10 January 2022

BLM Office Renovations
Pearl Public School District – Pearl, MS

ADDENDUM NO. 01

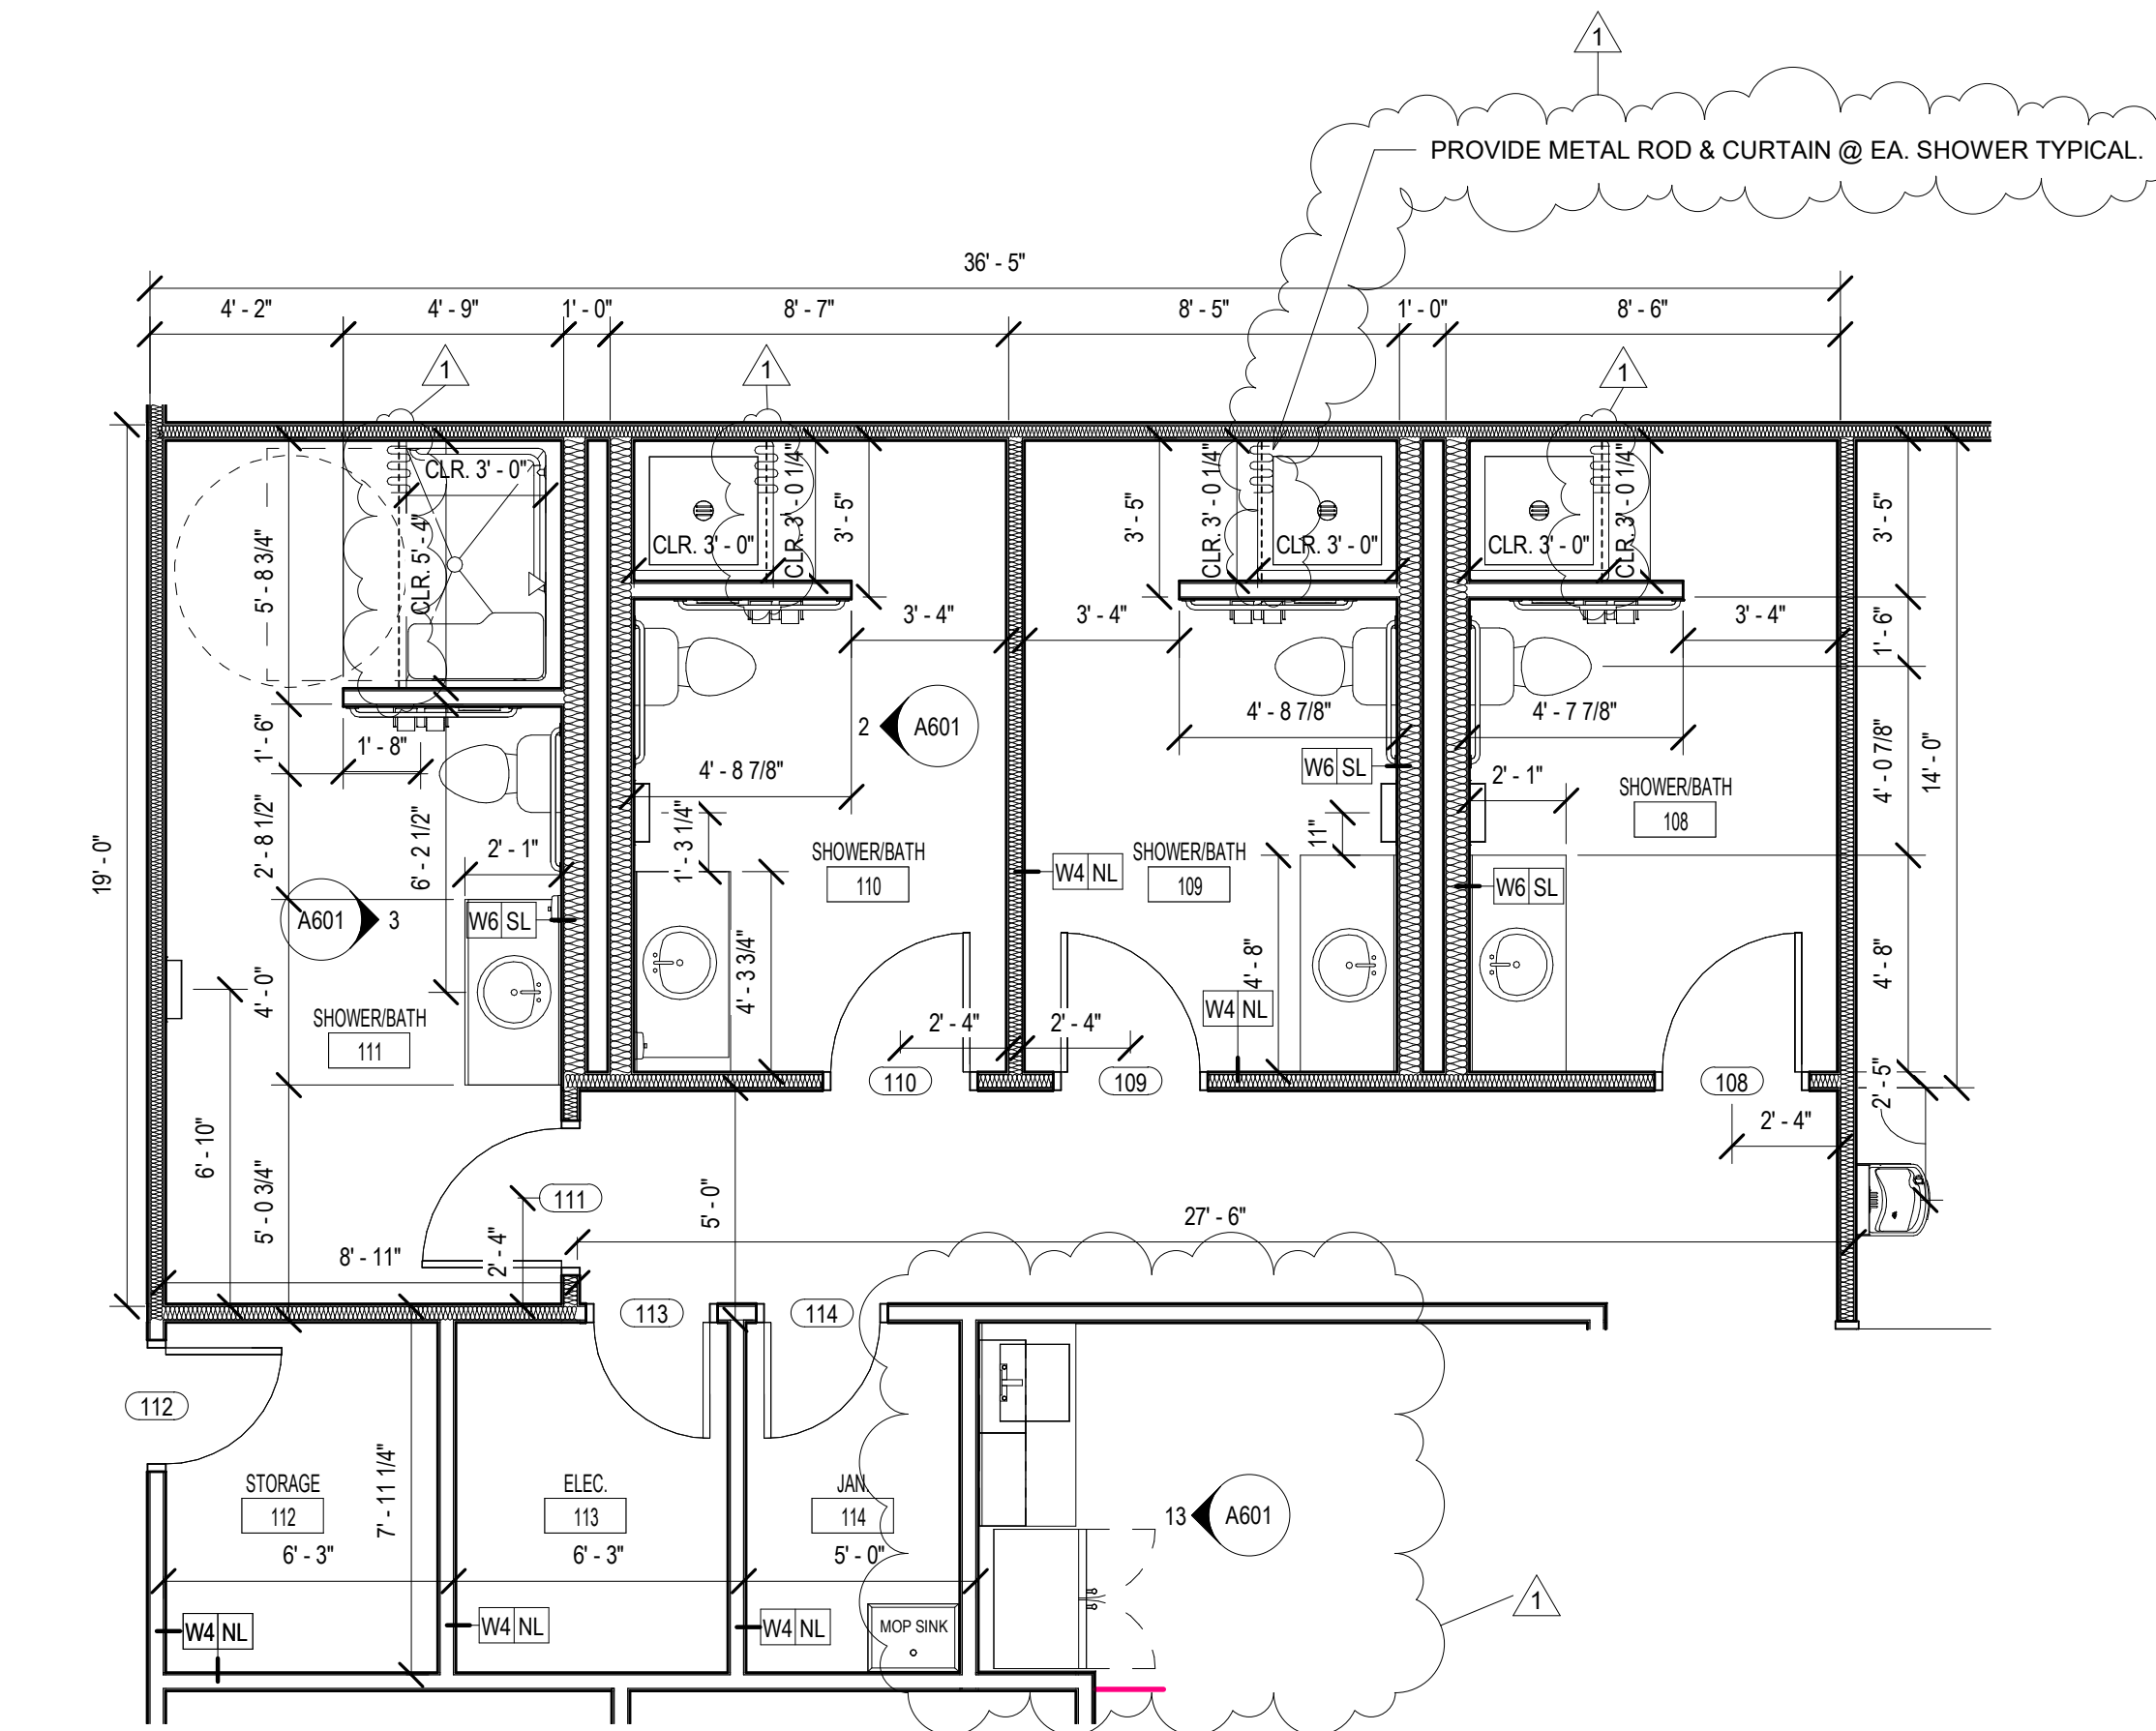
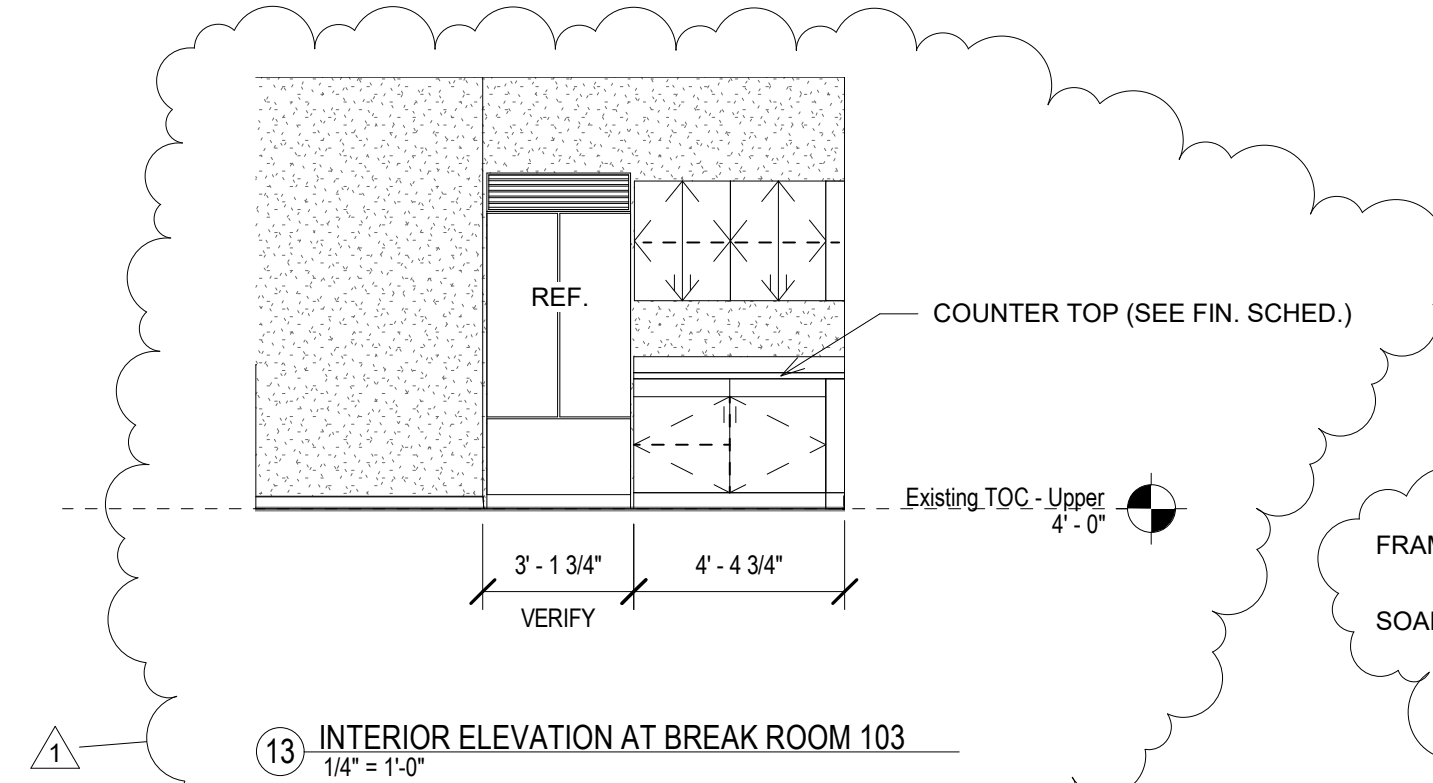
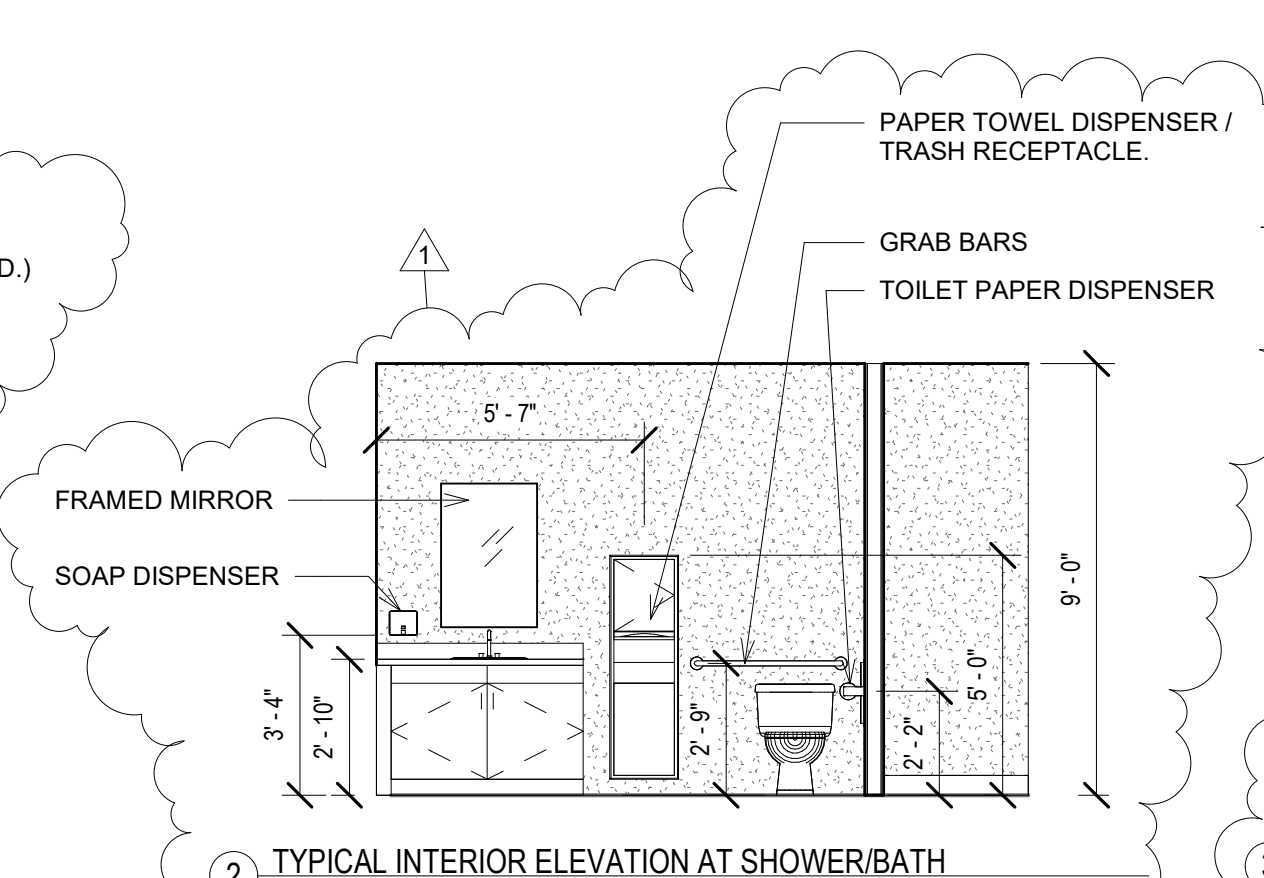
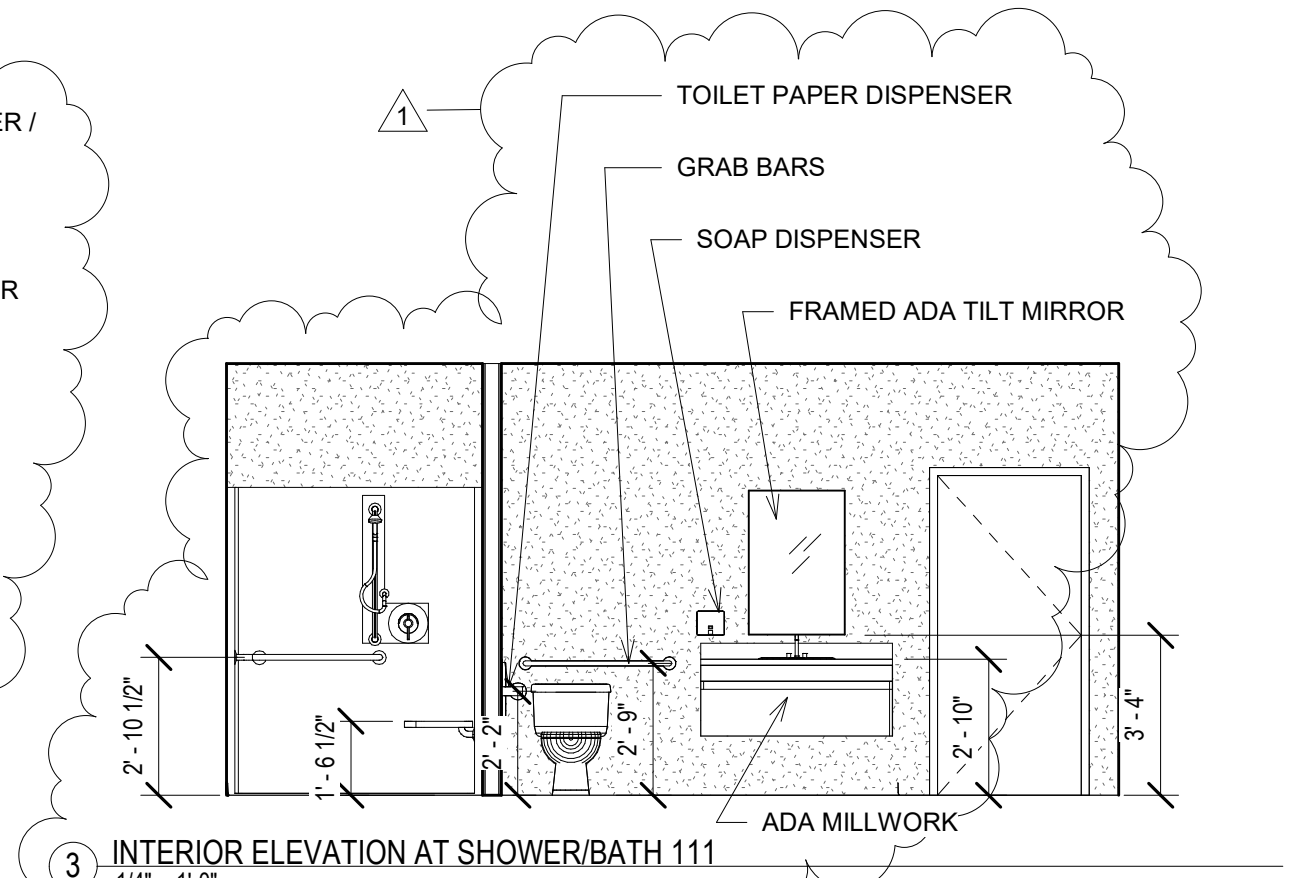
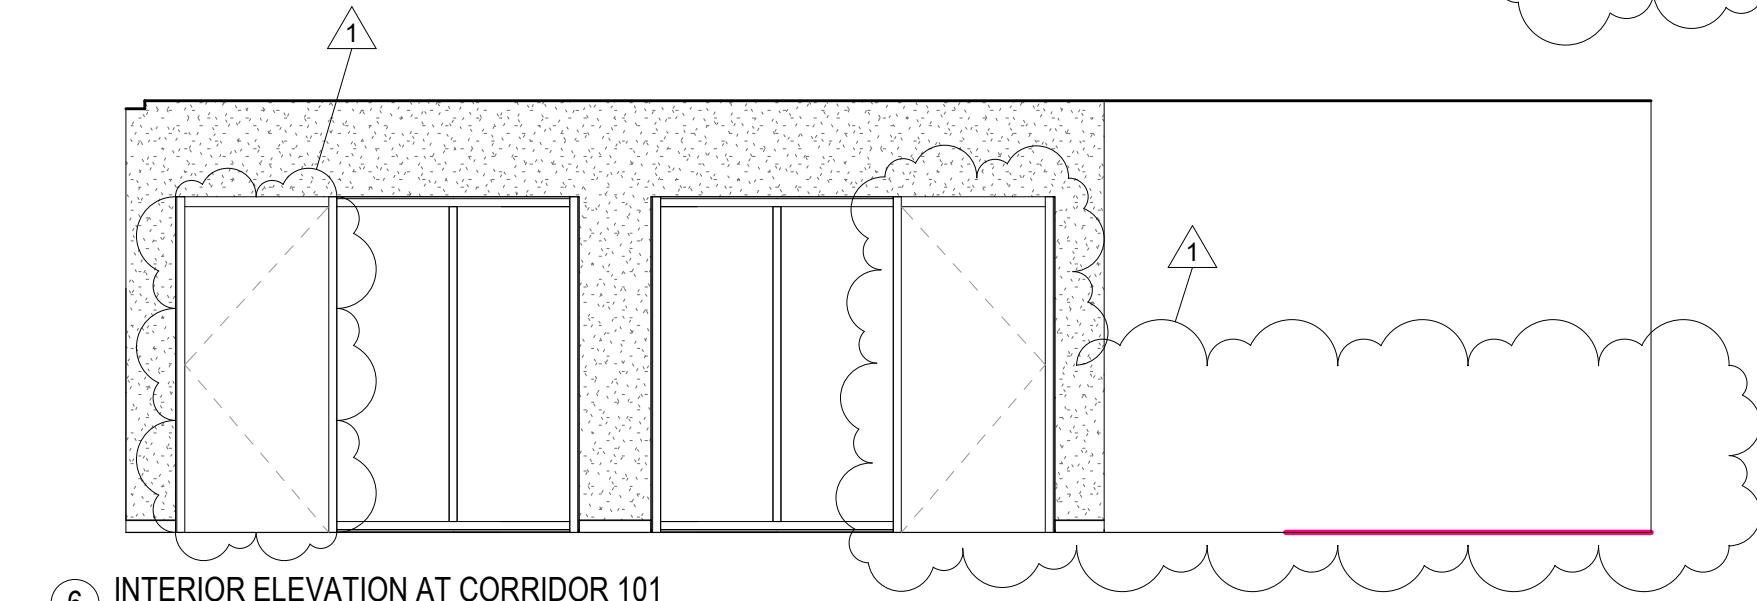
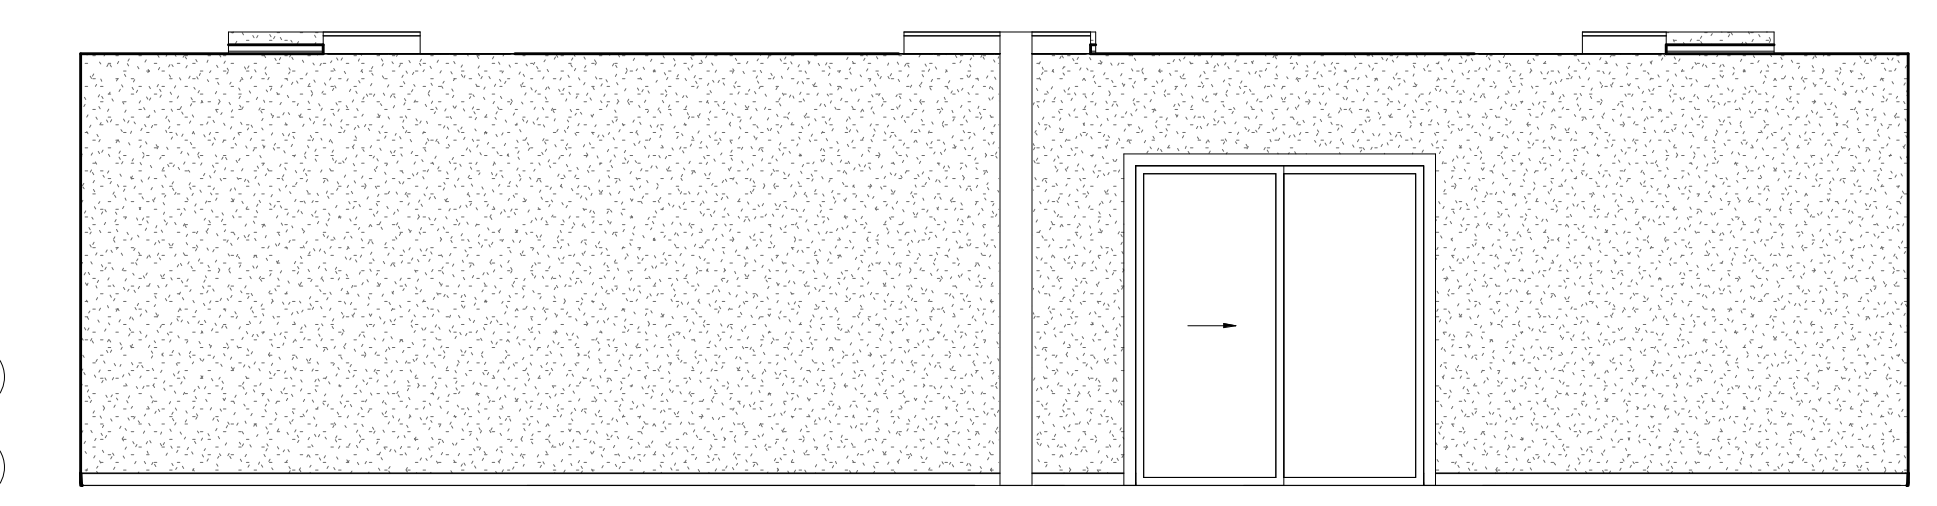
| ITEM NO. 11 | <p>A601 INTERIOR ELEVATIONS</p> <p>Revise per the enclosed sheet.</p> |
